Intended for
Viking Energy Wind Farm LLP

Project Number
1620009158

VIKING ENERGY WIND FARM PLANNING MONITORING OFFICER AUDIT REPORT 003: 2ND DECEMBER 2020 TO 26TH JANUARY 2021

Photo 17. Spur 22 (Nesting) on 27th January 2021 following reinstatement of peat which had been excavated on the day of the audit.

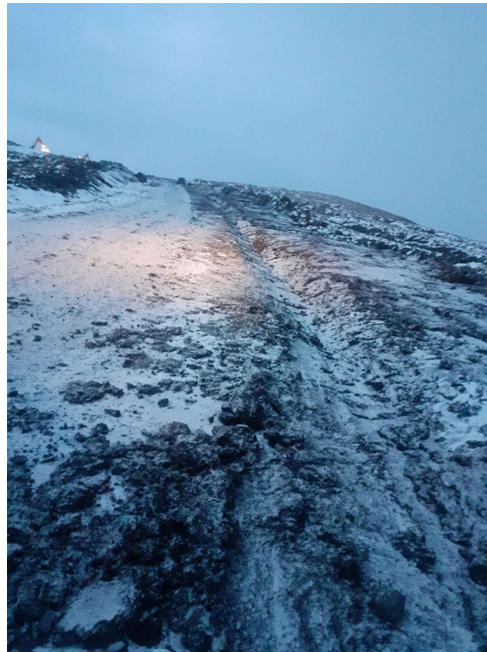
Freshly excavated peat was observed at the side of Spur 22 at the time of the audit. A member of the Principal Contractor team advised that this was part of ongoing reinstatement works. On the following day (27th January 2021) a photograph of the same area was provided to the PMO showing that the peat had been reinstated. More snow had fallen overnight which limited visual assessment of the area but this appeared to show that the peat had been appropriately reinstated as required. Photographs 16 and 17 show the area prior to and after reinstatement.
